**RE: Williamsburg Landing Nursing and Living Facility
(Now Woodhaven at Williamsburg)
Plan No. SP-50-96
BMP ID Codes: CC 012 (BMP 2 Timber Crib)
AES Project No. 8162**

Re: Williamsburg Landing (County Plan SP-50-96)
Nursing & Assisted Living Facility
Record Drawings and Construction Certification

Project: Williamsburg Landing Nursing & Living Facility (now Woodhaven at Williamsburg)
Plan No.: SP-50-96
BMP ID Codes: CC 011 (BMP 1 Dry Pond) & CC 012 (BMP 2 Timber Crib)

SITE AND UTILITY PLAN

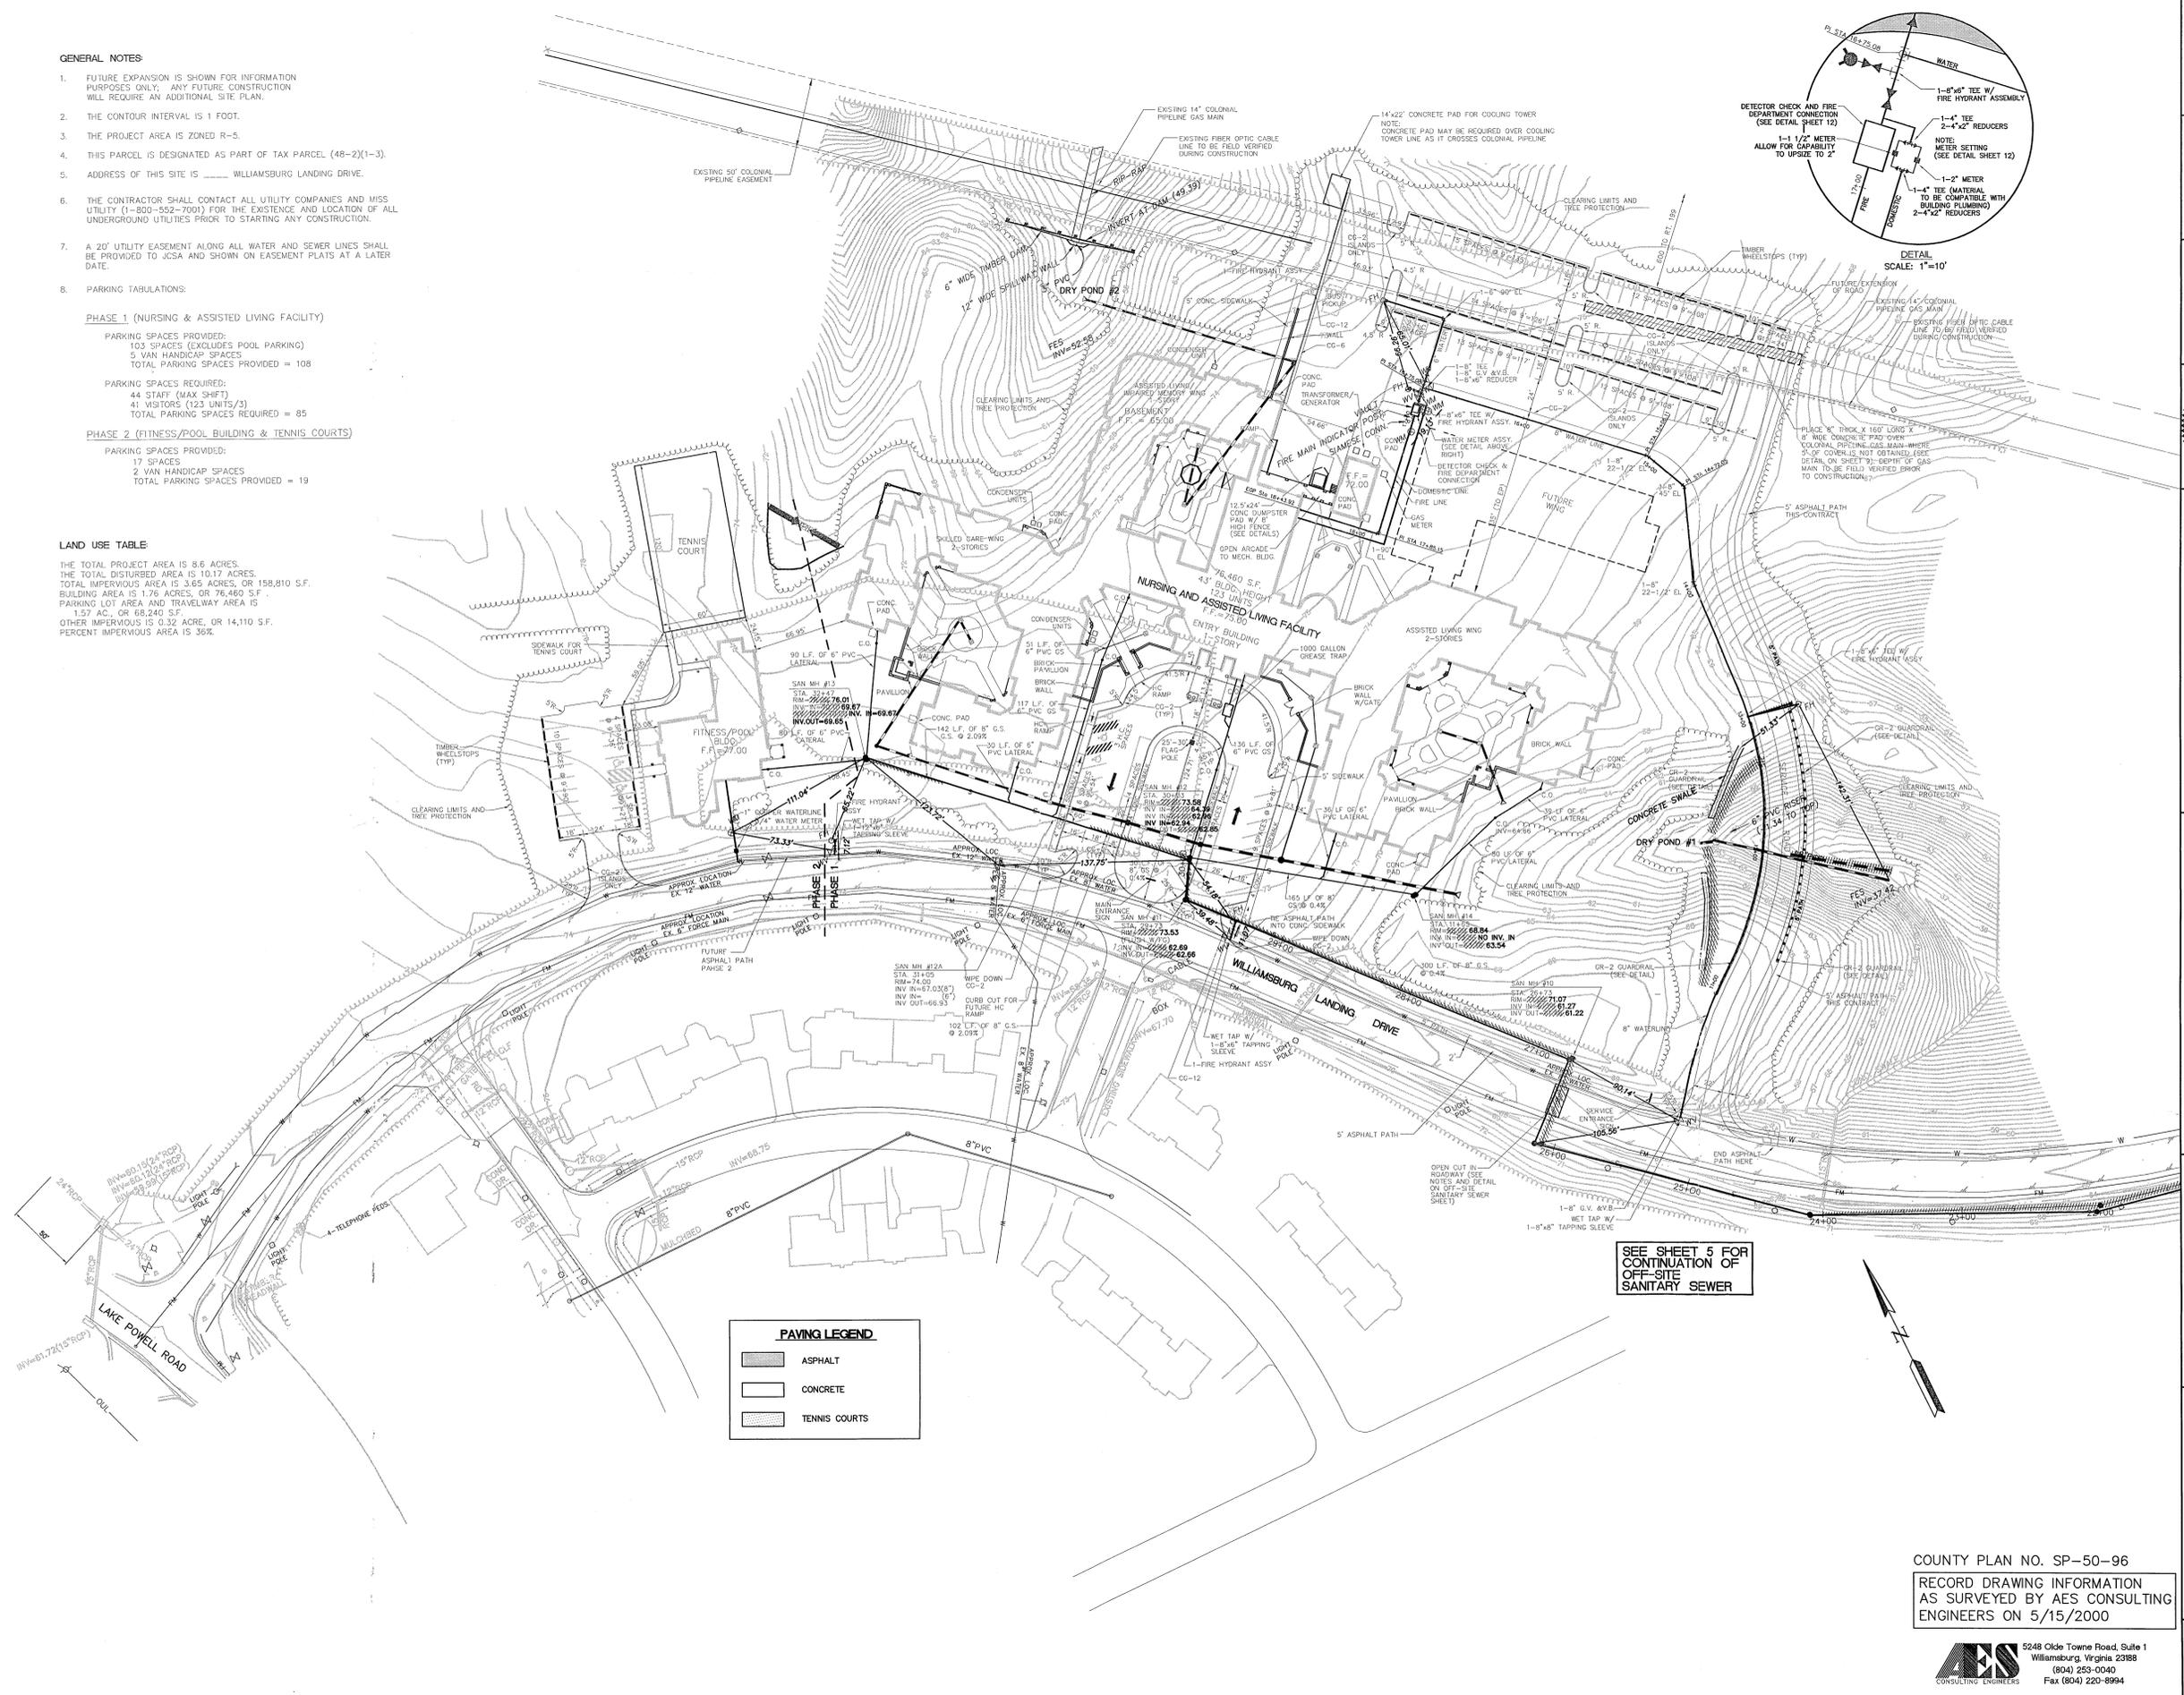
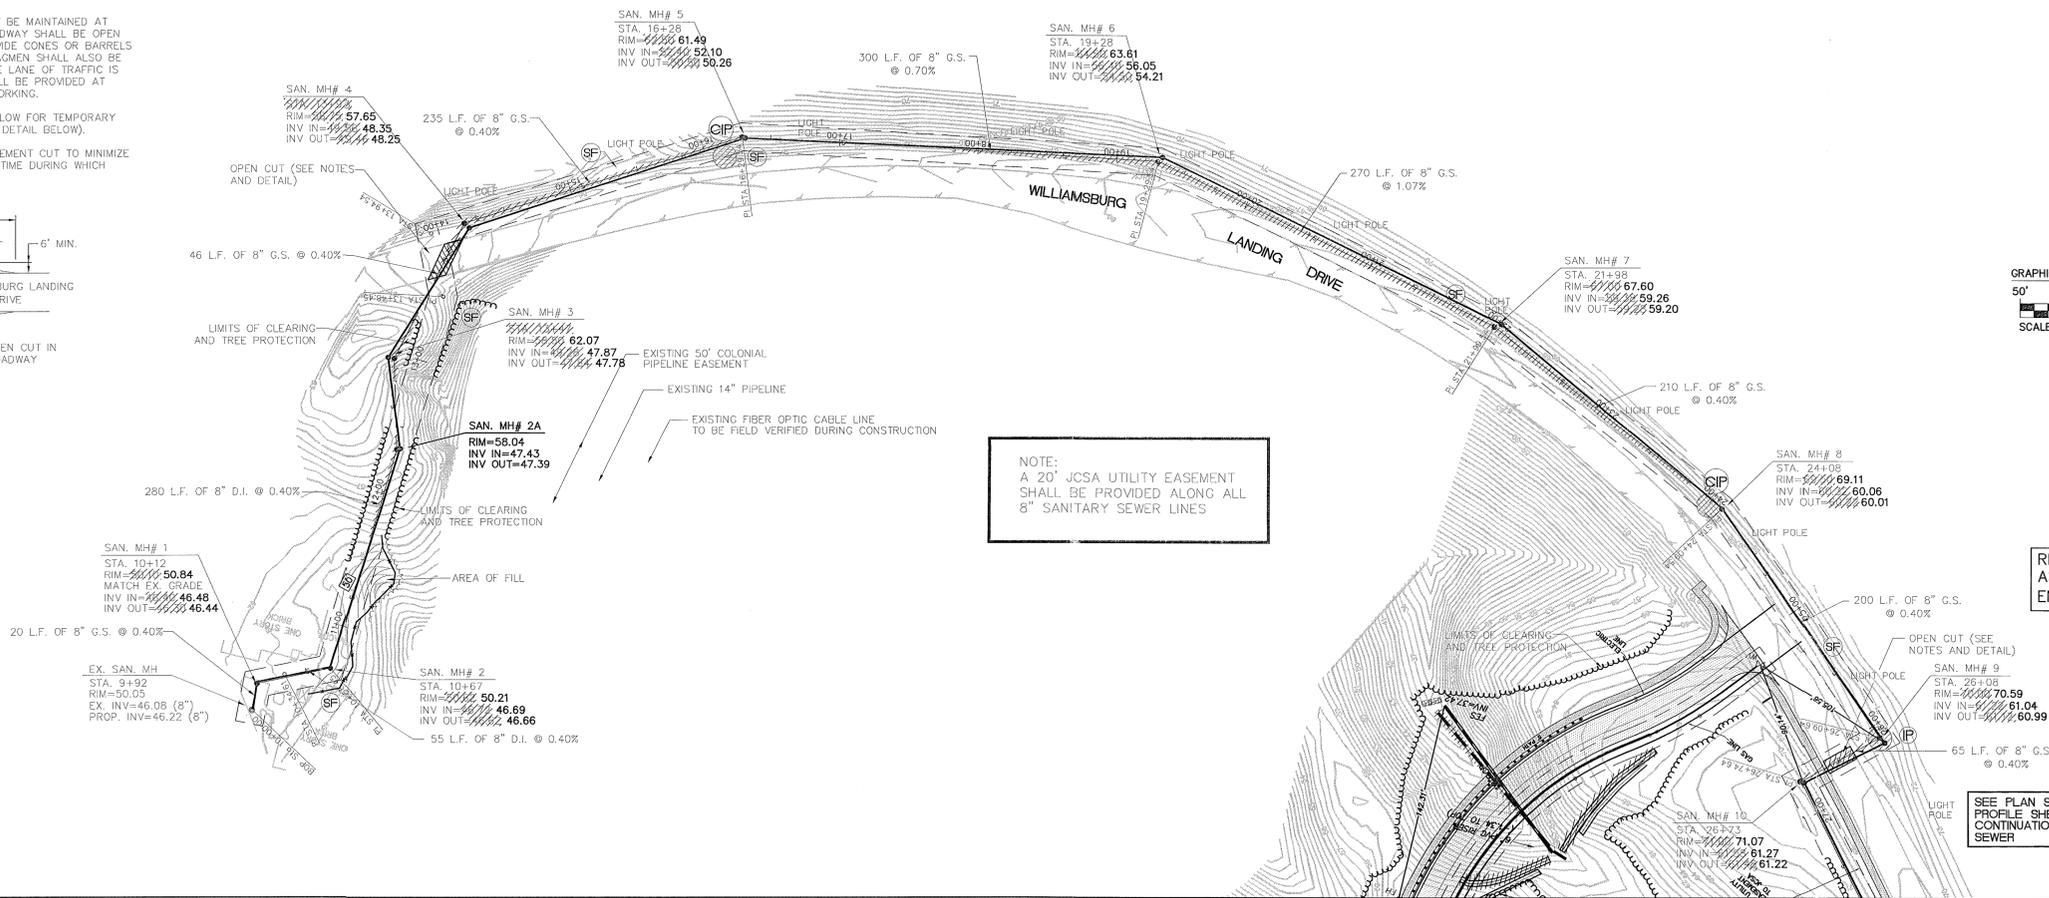
The Environmental Division has reviewed a record drawing set, consisting of Sheets C001, C005 and C010, as submitted to our office on June 7th for the above referenced project.

The record drawings dated May 15th 2000 provide as-built information for two stormwater management/BMP facilities on this site. Dry Pond # 1 is an embankment-type detention facility located approximately 100 feet east of the main building and just west of the service road. Dry Pond # 2 is a timber crib wall-type dry detention facility located along the north (back) side of the main building.

1. In accordance with Erosion and Sediment Control Note # 18 on Sheet 009 of the approved plan, construction certifications for the BMP's are required. None were provided.
2. Add approved County plan number (SP-50-96) at the bottom right hand corner of each sheet.
3. Consistently add labels Dry Pond # 1 and Dry Pond # 2, as appropriate, on record drawing plan views and details.
4. Dry Pond # 1. The as-built invert-in and invert-out elevation for the pond outlet barrel would result in an as-built pond barrel slope different from that of the approved design plan. Make this correction on the detail on record drawing Sheet C010 as necessary.
5. Date and sign the professional seal as provided on each of the record drawing sheets.

9. Dry Pond # 1. An erosion/scour hole about 10' L x 8' W x 2' deep is present at the outfall end of the 18 inch pond outlet barrel. This area is located on the east side of the service road. The scour hole was temporarily filled with scrap 12 inch diameter cut wood logs. The wood logs need removed and the rock outlet protection pad needs re-established in accordance with the approved plan or with heavier or larger sized riprap.

11. Dry Pond # 2. The 3 inch diameter PVC riser needs perforated in accordance with the approved plan. Perforations were only visible on the bottom portion of the riser. Also, perforations that are present in the bottom half of the riser were clogged with organic material and need cleaned.
